**MOOERS LANDFILL
REMEDIAL INVESTIGATION/FEASIBILITY STUDY**

WORK PLAN

NOVEMBER 1990

RE: Mooers Landfill - Site #510005
RI/FS Final Draft Work Plan

Figure 6-1
MOOERS LANDFILL
 PROJECT MANAGEMENT STRUCTURE

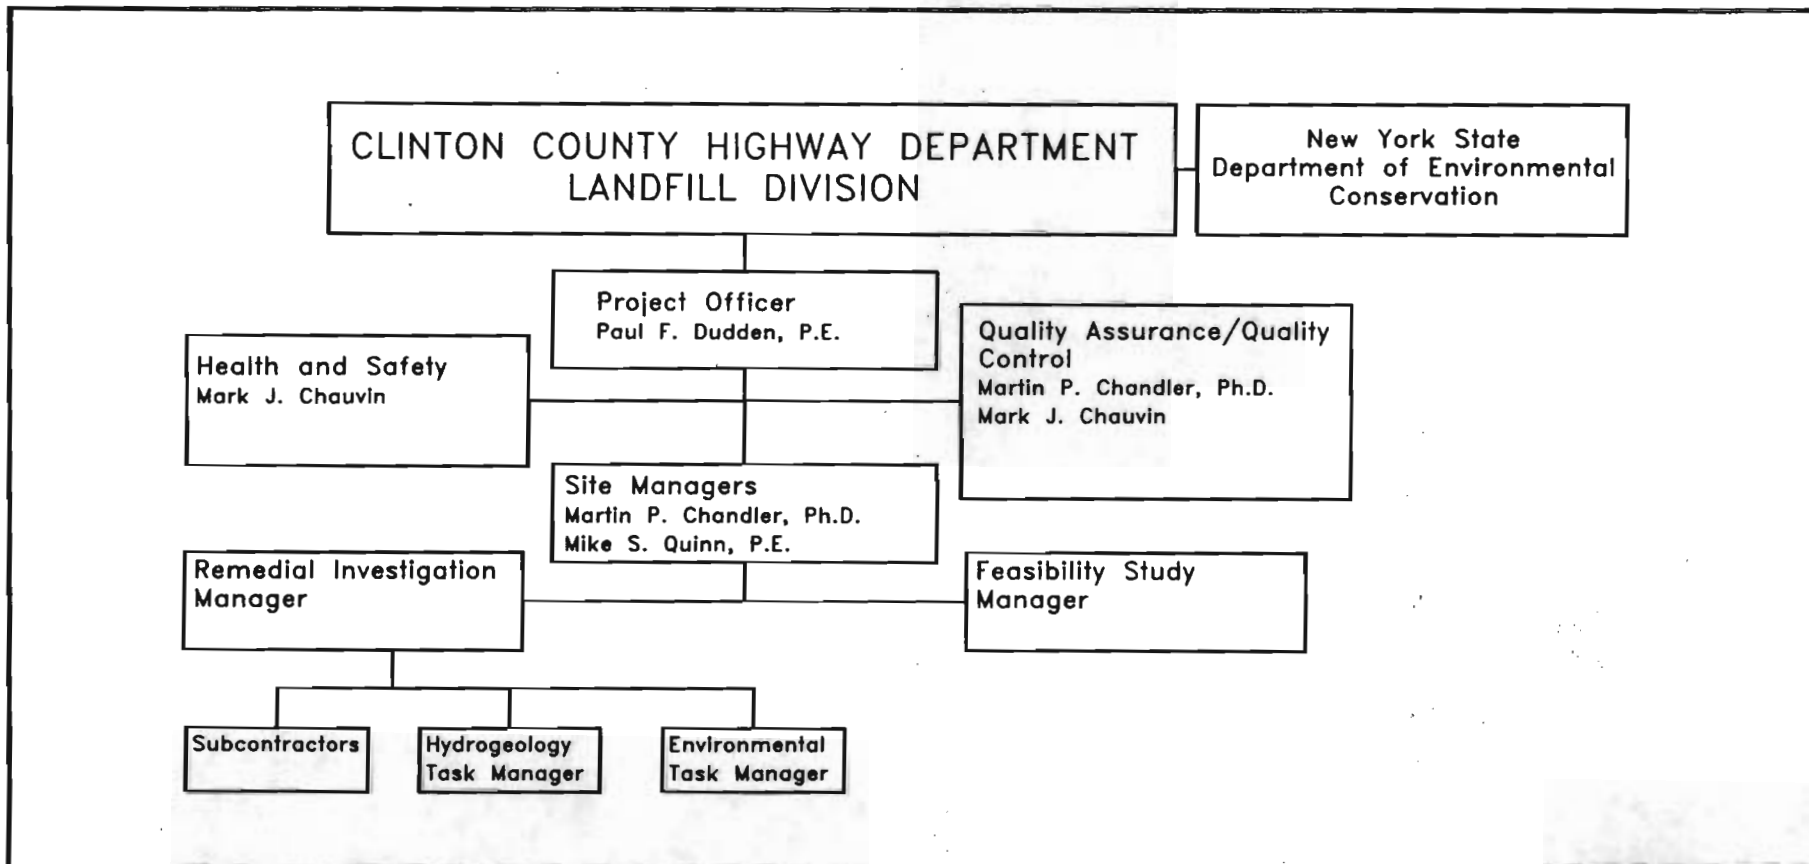
6.0 Project Management Plan - If Section 6 is to fulfill the requirements of a Project Management Plan required in the standard State Assistance Contract, then Section 6 must describe Clinton County's project management structure in addition to the information provided in the Work Plan.

The Work Plan should also include a project personal organizational chart, and should designate a qualified Quality Assurance Officer. The resume for the QA Officer must be included.

6.0	<p>It is not our intent that Section 6.0 fulfill the project management plan requirements stipulated as part of a standard State Assistance Contract. Rather, Section 6.0 is to serve as an outline of the project management structure. To this end, we have retitled this section as Section 6.0 - Project Management Structure to avoid any future misunderstandings.</p> <p>The Project Management Plan requirement outlined by the NYSDEC comment will be addressed during the State Assistance Contract Application process.</p>
SAP - App. A

- 6.0 Section 6.0 of the Work Plan has been restructured to include a project management plan and revised schedule.
- A résumé of the QA/QC Officer(s) will be sent to the NYSDEC under a separate letter following this submission.
